Notice of a meeting of Planning Committee

Thursday, 21 March 2019
6.00 pm

APPLICATION NO: 19/00088/FUL	OFFICER: Miss Claire Donnelly
DATE REGISTERED: 17th January 2019	DATE OF EXPIRY : 14th March 2019
WARD: Park	PARISH:
APPLICANT:	Dr & Mrs Saha
LOCATION:	16 Rowena Cade Avenue, Cheltenham
PROPOSAL:	Single storey rear extension and alterations to front and rear elevations to include Juliette balconies

ADDITIONAL REPRESENTATIONS

Single storey extension

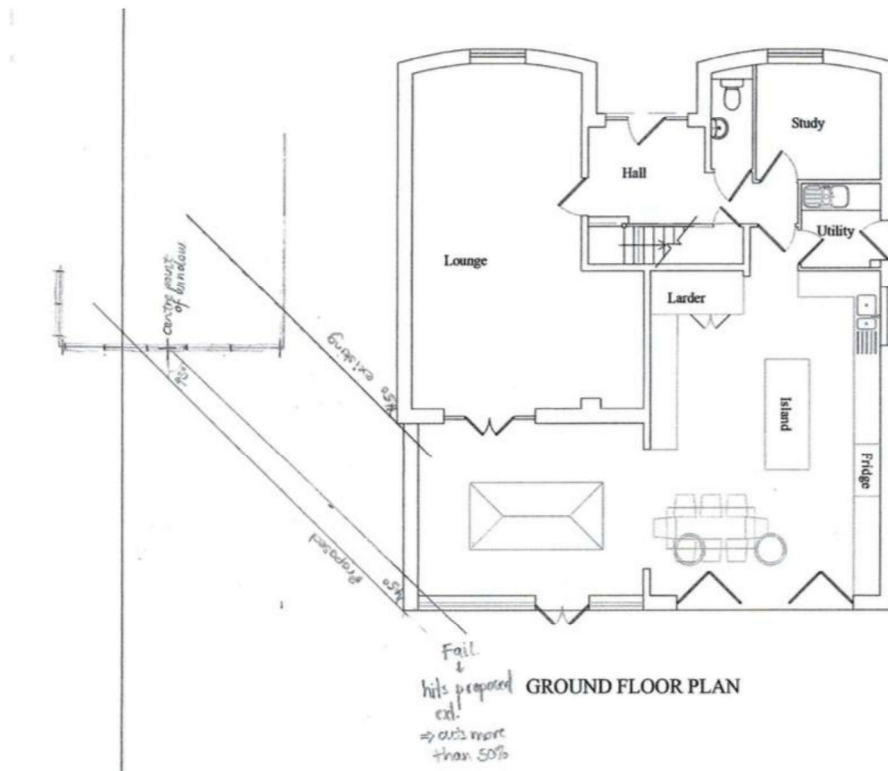
We do however remain concerned about the depth of the extension, at 4.2m on our side. The property at number 16 is set back further from the road than our own home and already results in the rear of our home losing light, sunlight and being overshadowed, particularly to our lounge and patio, during the day. In an attempt to compensate for this we added large glass sliding doors to our lounge to maximize light into these areas, and also to allow light to flow through to the patio, dining room and kitchen.

With reference to paragraph 6.17 of the Officers report, we believe that due to the orientation of our home and garden (WNW facing) means that should this application be allowed at the 4.2m depth proposed, we will suffer even more from an increased loss of light, sunlight and additional overshadowing to our lounge and dining room.

In addition although a light test has been conducted we have been advised by the planning office that the proposal fails on one of the tests, which unfortunately will impact on these rooms; the main living areas of our home. A copy of the drawing, annotated to show the existing and proposed effect, is below.

We believe that just a small reduction in the depth on this elevation would redress this issue and mean that we would enjoy the same amenity as we do now, whilst still allowing our neighbours an extension to meet their wishes.
